# Water Licence Inspection Report

| Authorization | Representative |
|---|---|
| **Municipality of Cambridge Bay** | **Beni Gatsoundou** |
| **3BM-CAM2030** | **Assistant SAO** |
| **August 26, 2026** | **Jonathan Mesher** |

| Photo # | 2 | Coordinates: | 3BM-CAM2030 municipal Landfill |

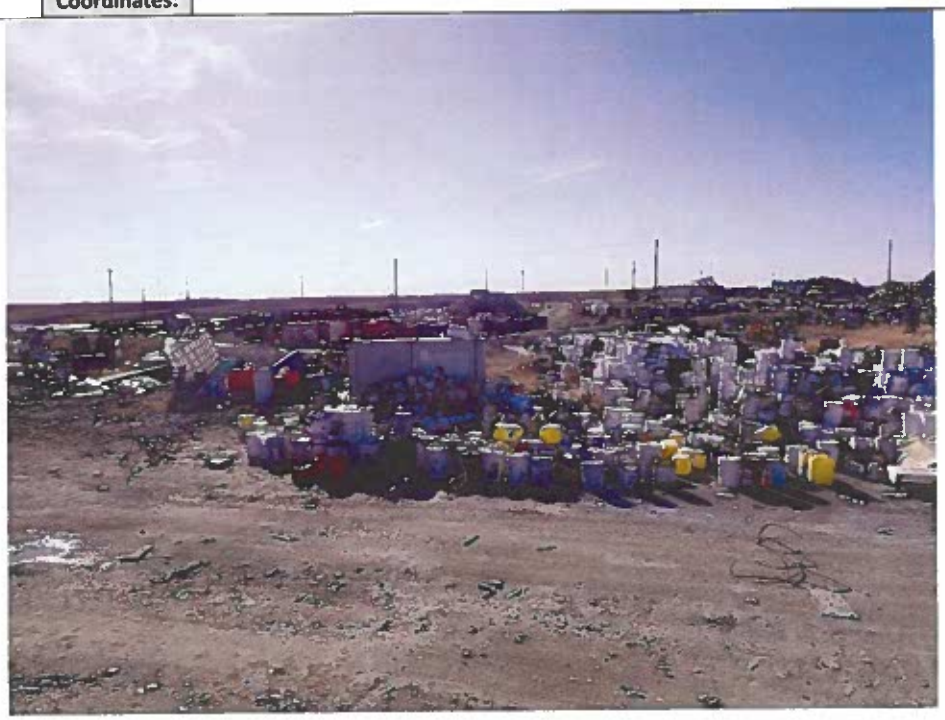
b) The licensee has not been separating burnable waste from non-burnable waste and is indiscriminately burning wa Section 5.2 of the operation and maintenance manual states "Materials such as cardboard, untreated wood prod natural fiber textiles should be diverted to the burn pit." see photos 1 and 2 for the lack of separation between no burnable waste.

d) Section, 6.4 Litter Control, states the following "Limit the size of operating areas so that waste can be compacted and covered at regular intervals;" and "The Landfill Operator shall regularly collect litter from the site, surrounding areas and along access roads." The licensee is not cover the waste and it does not appear they are collecting litter around the surrounding areas. See photos 1 and 2 for the lack of cover material causing windblow litter.

The licensee has not notified the inspector or provided the required information described in Part D, item 10 of the licence 3BM-CAM2030. See photos 2 and 3 for photos of open burning at the landfill.

Landfill not managed as approved and burning of materials not approved in the licence.

b. The licensee to ensure open burns only occur as approved and the required information regarding the open burn is provided in the annual report and the notice to the inspector.

d. The licensee is to pick up the windblown litter surrounding the landfill as described in section 6.4 of the Hamlet of Cambridge Bay Municipal Solid Waste Disposal Facility Operation and Maintenance Manual.
